**ATTACHMENT B-1**

MARKED UP PAGES FOR  
PROPOSED CHANGES TO APPENDIX A,  
TECHNICAL SPECIFICATIONS, OF  
FACILITY OPERATING LICENSES  
NPF-37 and NPF-66

BORON CREDIT IN THE SPENT FUEL POOL

BYRON STATION UNITS 1 & 2  
REVISED PAGES:

FIGURE 5.6-1

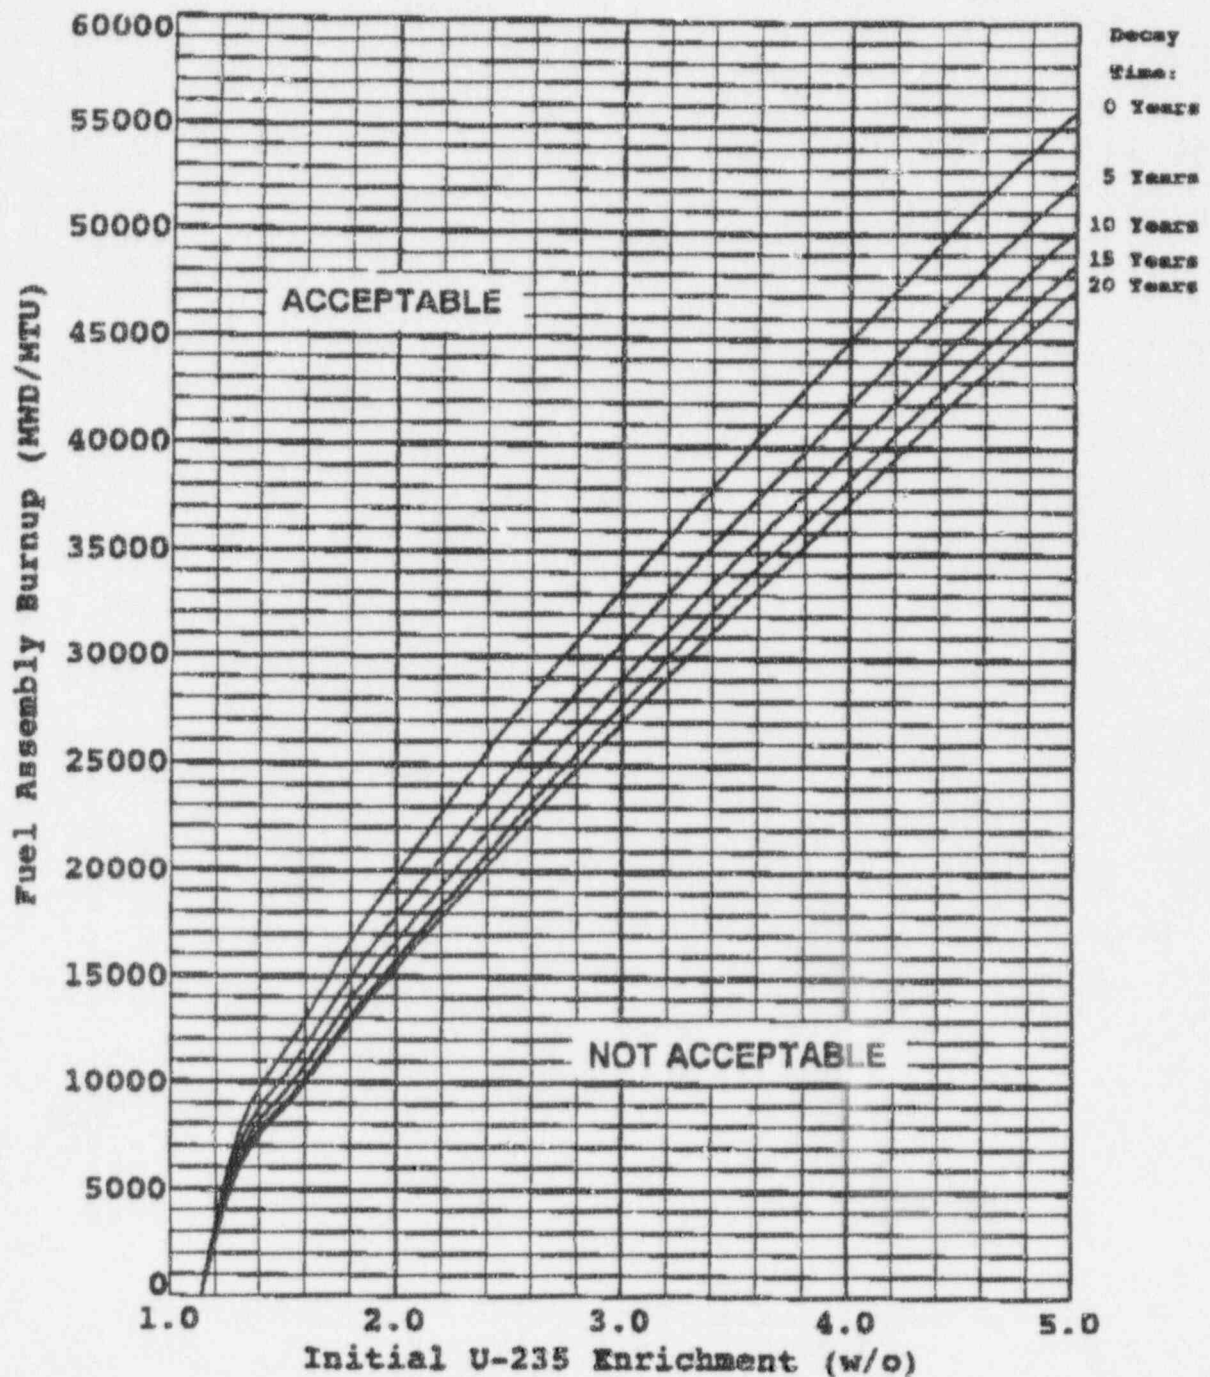
# INSERT C-1

MINIMUM BURNUP VERSUS INITIAL ENRICHMENT FOR REGION 2  
ALL CELL CONFIGURATION STORAGE

Note: The use of linear interpolation between the minimum burnups is acceptable.

FIGURE 5.6-2

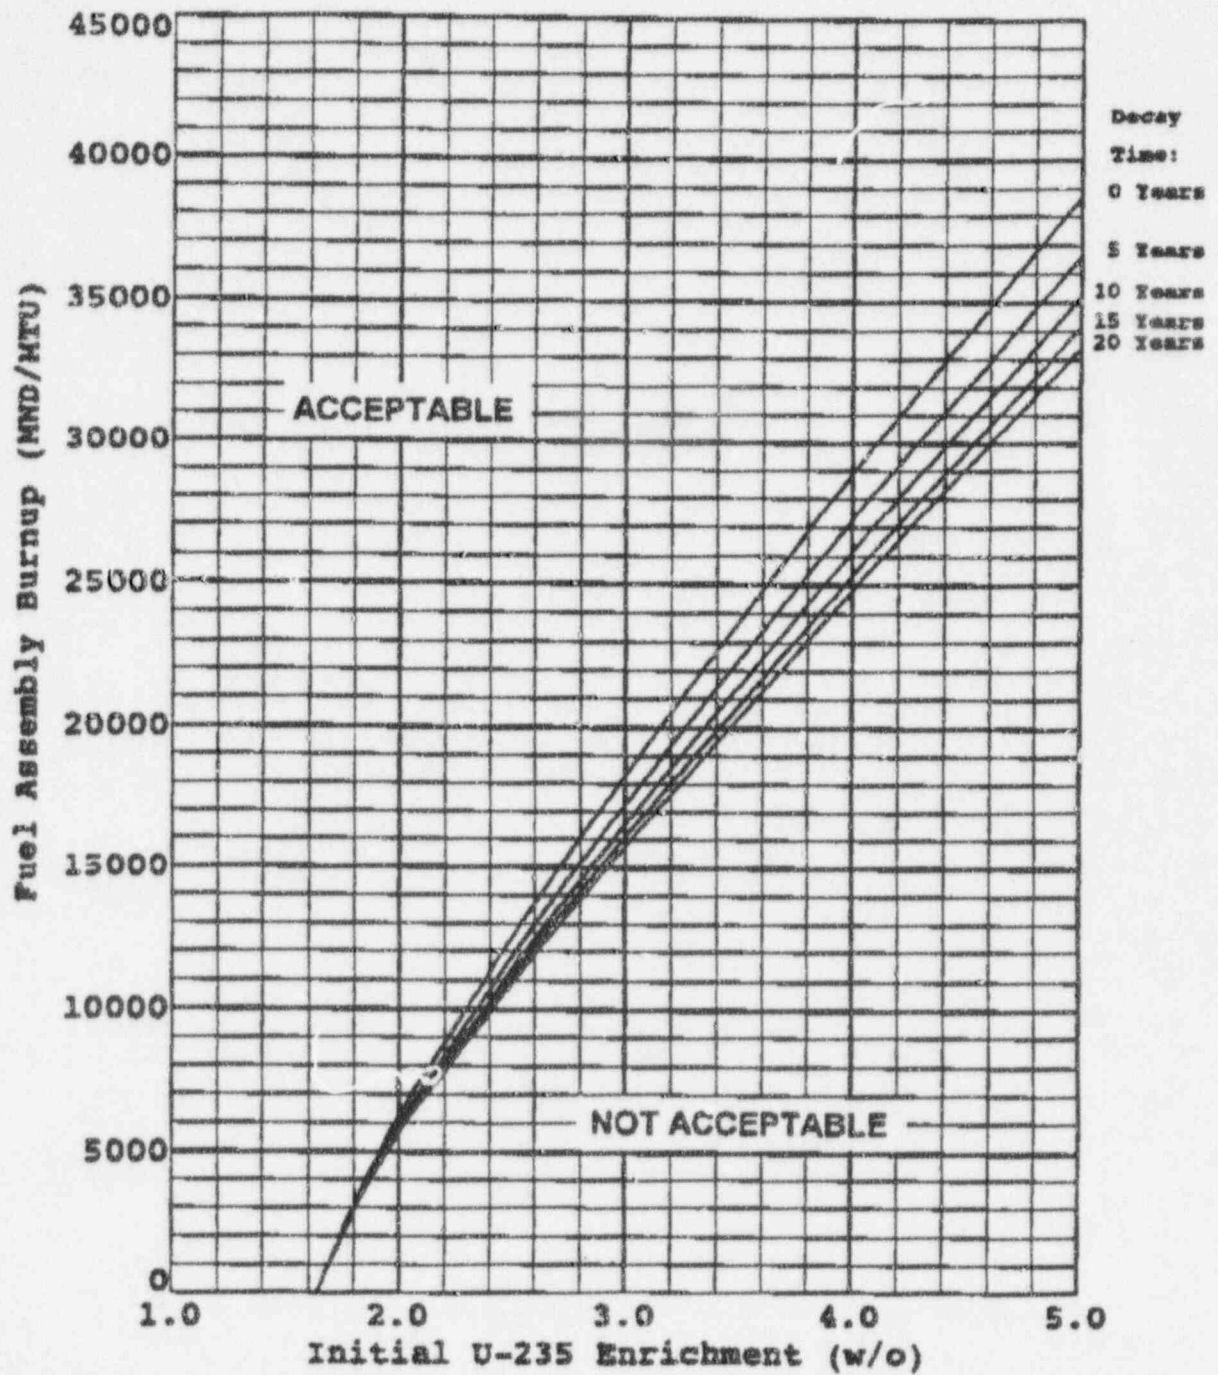
# INSERT C-2

MINIMUM BURNUP VERSUS INITIAL ENRICHMENT FOR REGION 2  
3-OUT-OF-4 CHECKERBOARD CONFIGURATION

Note: The use of linear interpolation between the minimum burnups is acceptable.

FIGURE 5.6-3

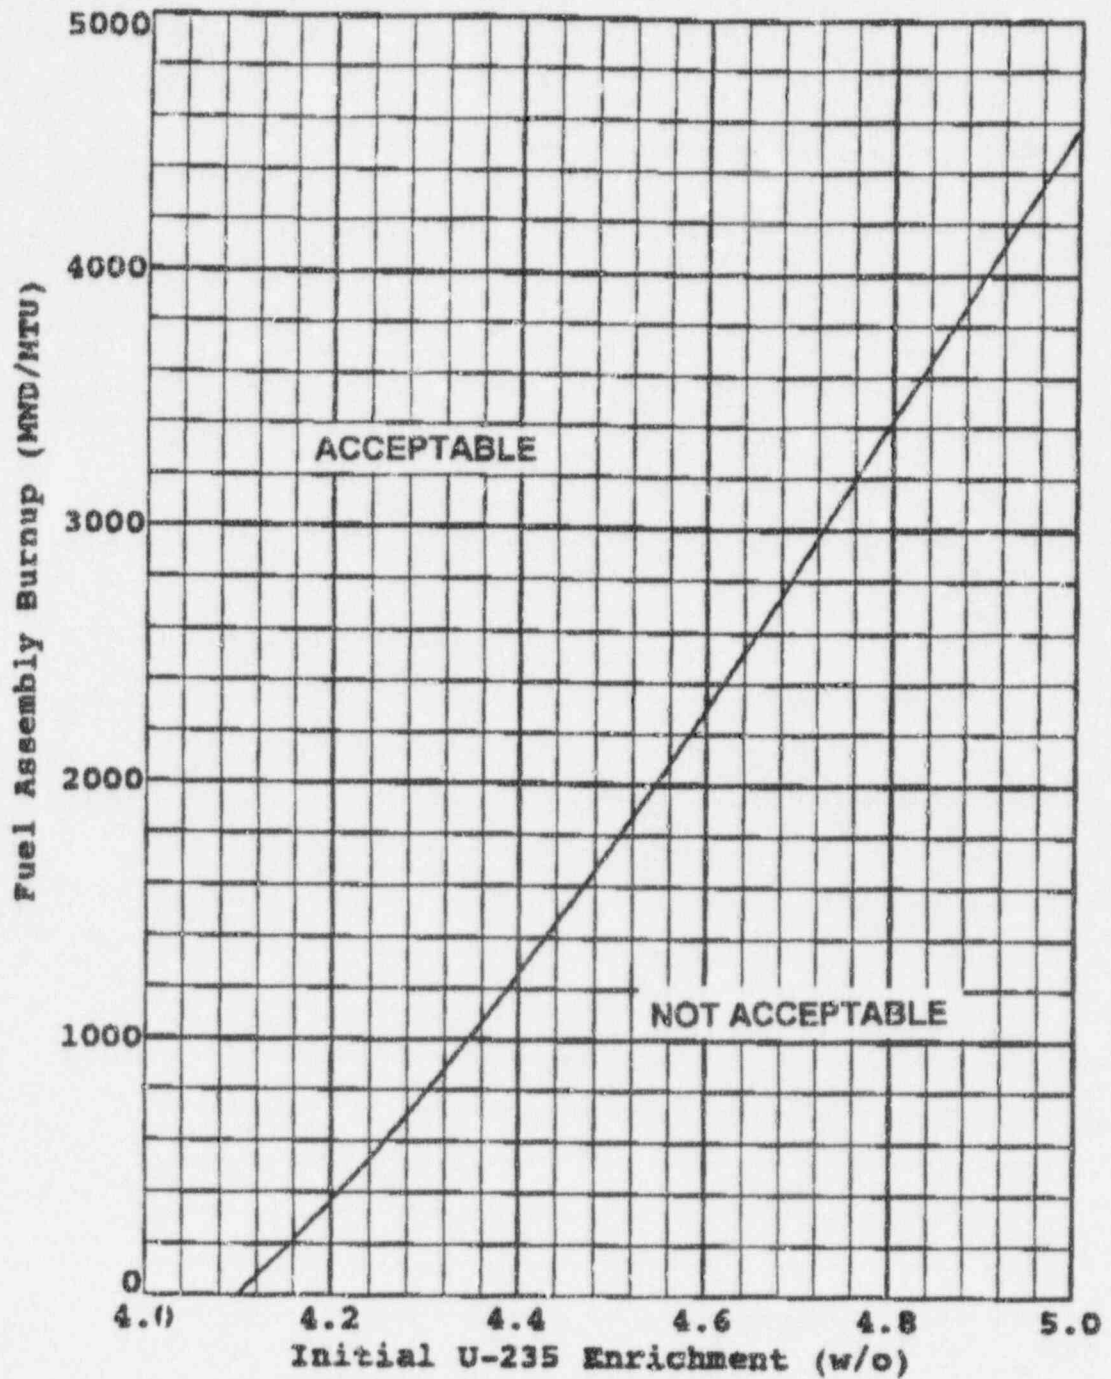
INSERT C-3

MINIMUM BURNUP VERSUS INITIAL ENRICHMENT FOR REGION 2  
2-OUT-OF-4 CHECKERBOARD CONFIGURATION

Note: The use of linear interpolation between the minimum burnups is acceptable.

FIGURE 5.6-1

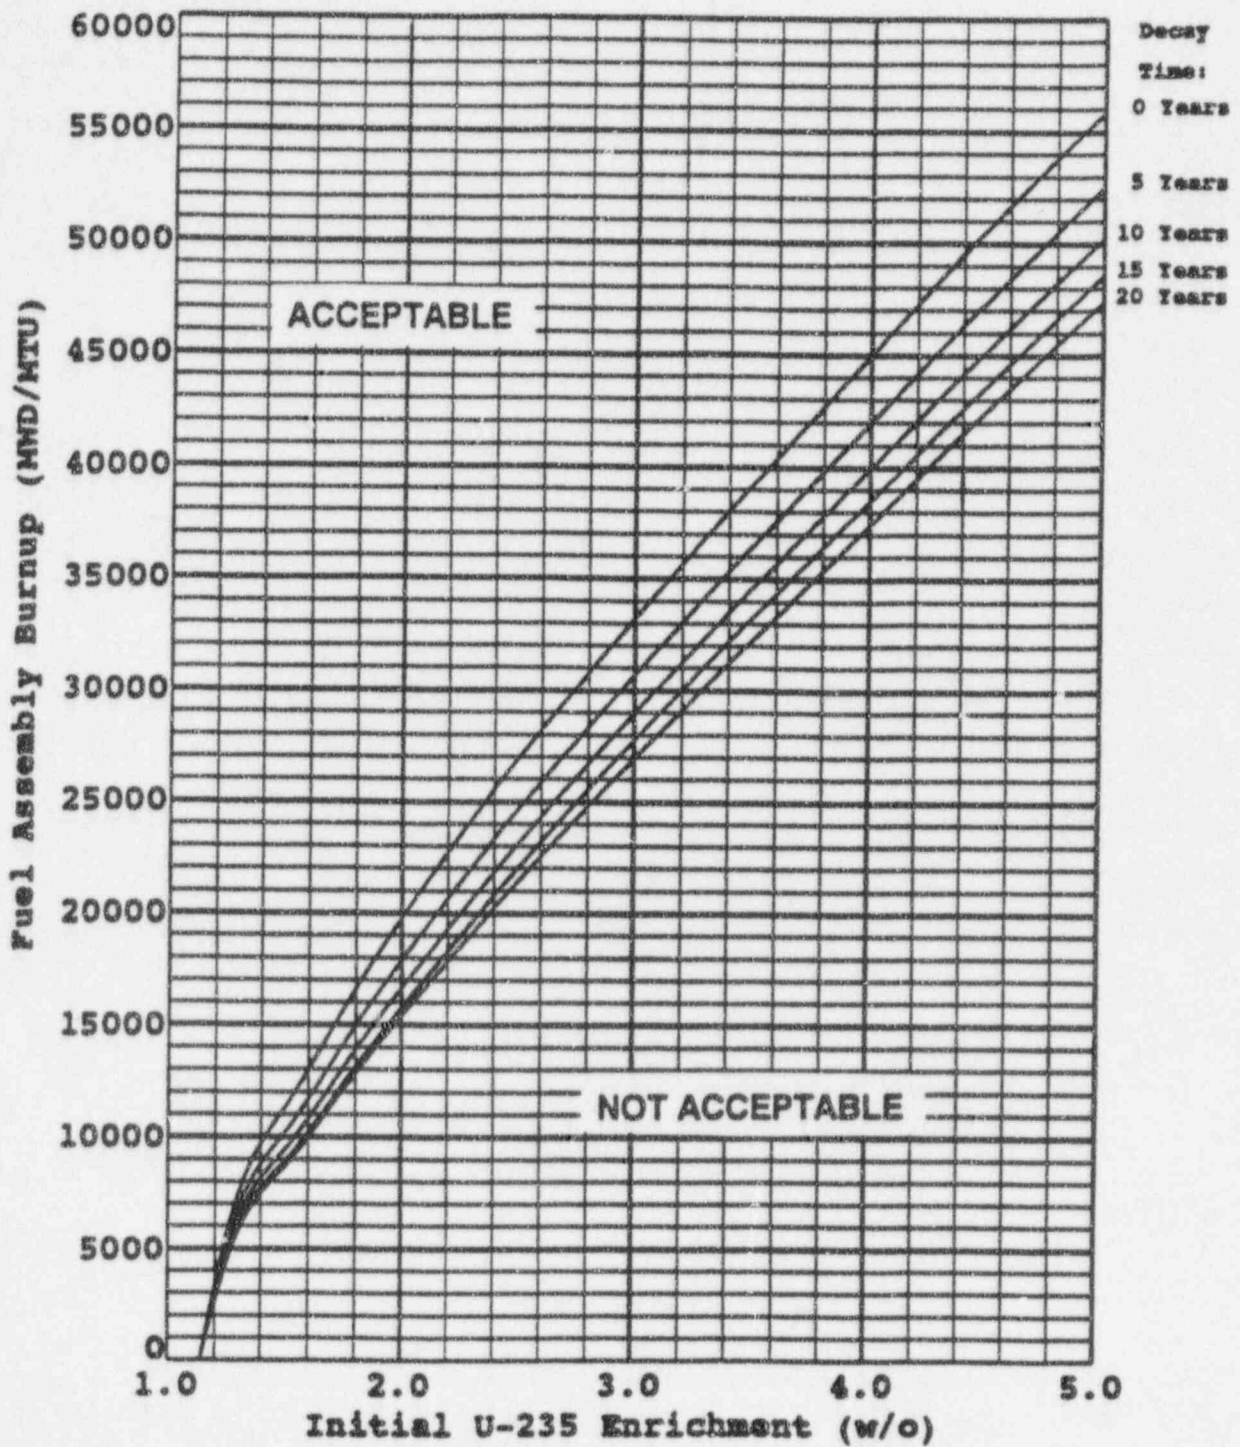
# INSERT C-1

MINIMUM BURNUP VERSUS INITIAL ENRICHMENT FOR REGION 2  
ALL CELL CONFIGURATION STORAGE

Note: The use of linear interpolation between the minimum burnups is acceptable.

FIGURE 5.6-2

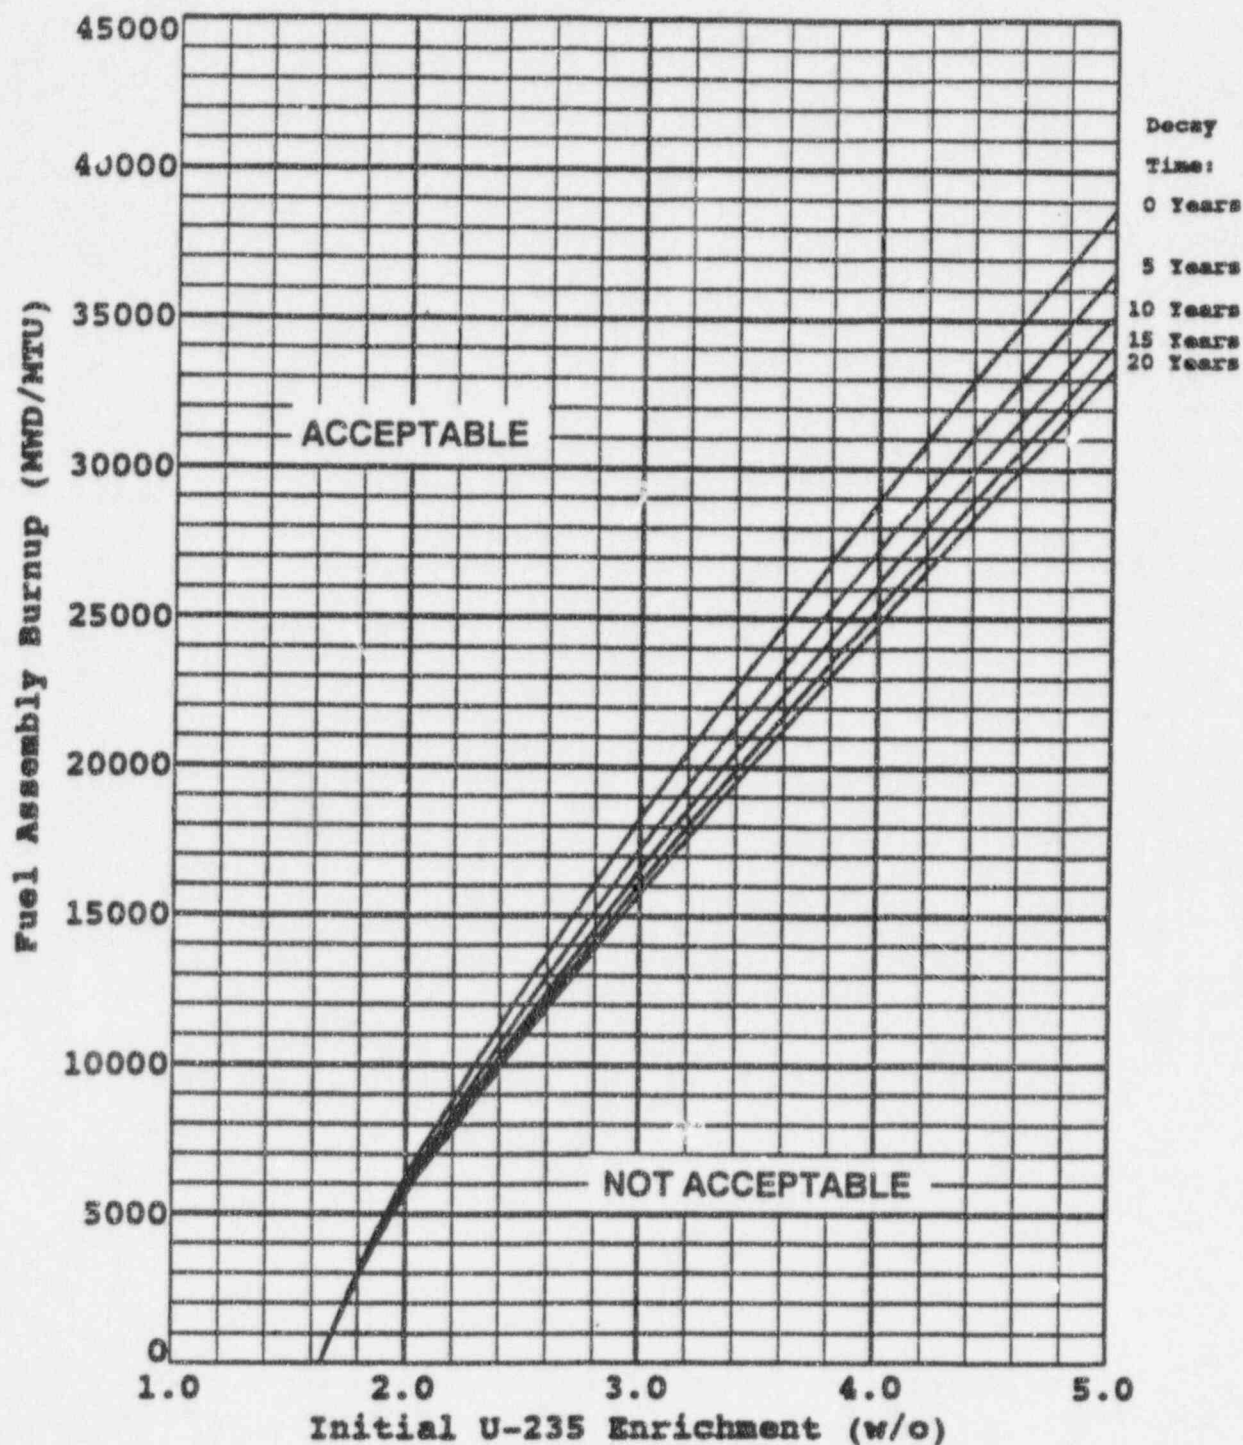
INSERT C-2

MINIMUM BURNUP VERSUS INITIAL ENRICHMENT FOR REGION 2  
3-OUT-OF-4 CHECKERBOARD CONFIGURATION

Note: The use of linear interpolation between the minimum burnups is acceptable.

FIGURE 5.6-3

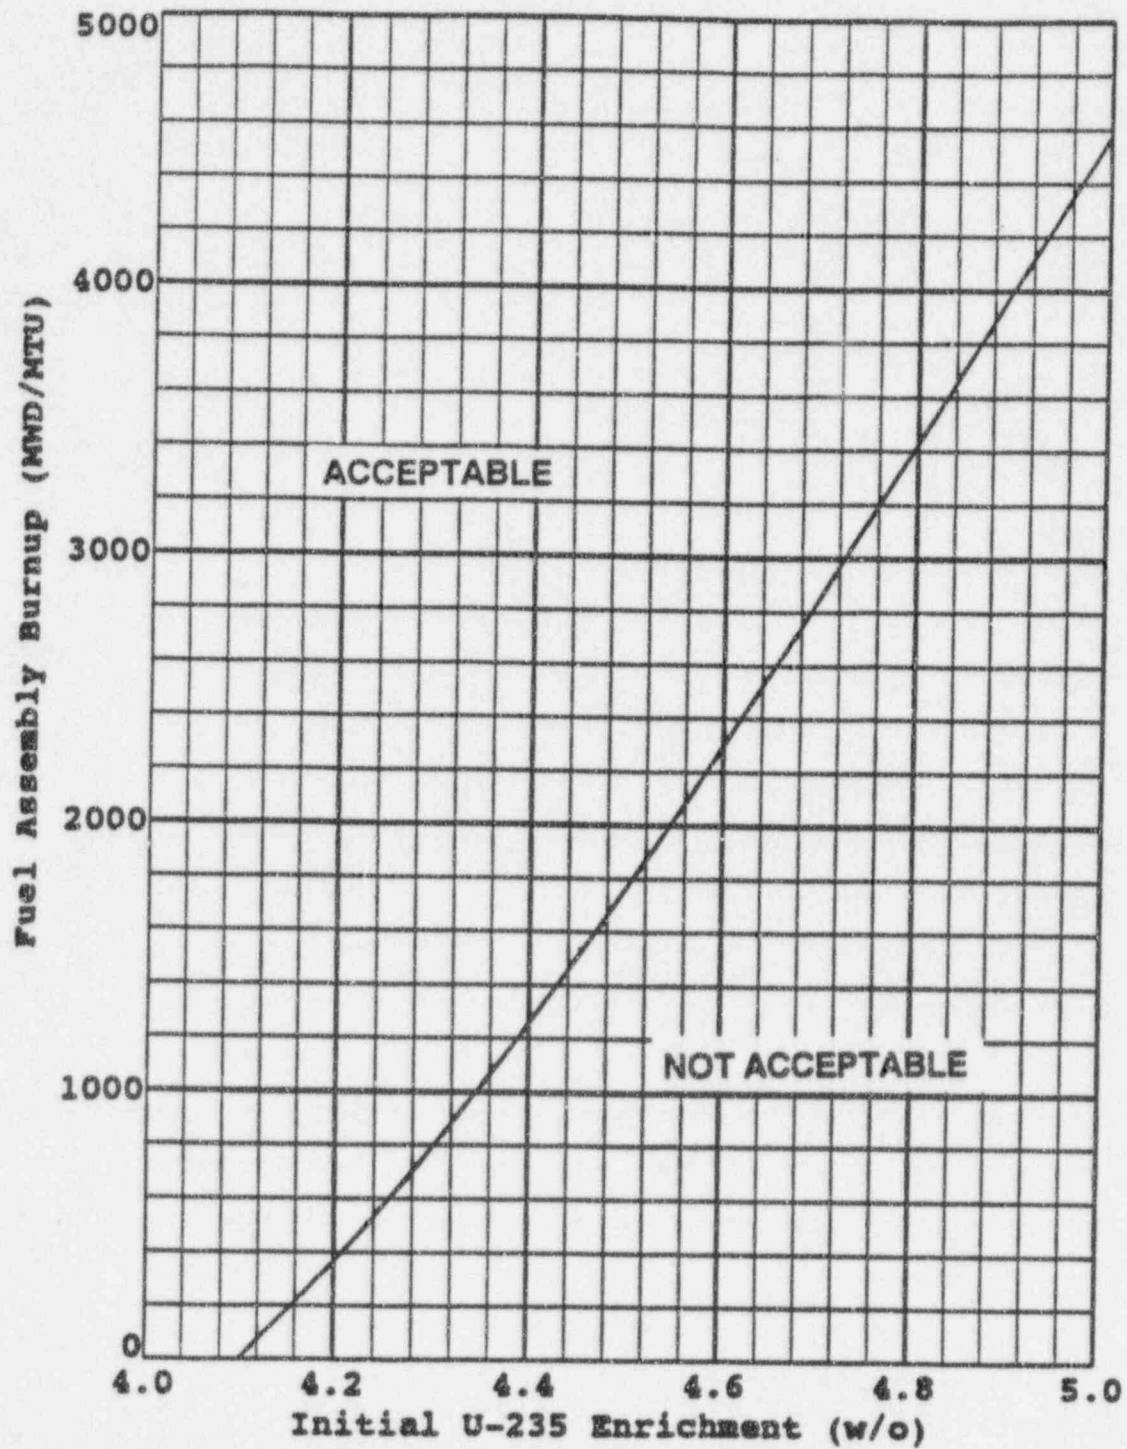
MINIMUM BURNUP VERSUS INITIAL ENRICHMENT FOR REGION 2  
2-OUT-OF-4 CHECKERBOARD CONFIGURATION

Note: The use of linear interpolation between the minimum burnups is acceptable.
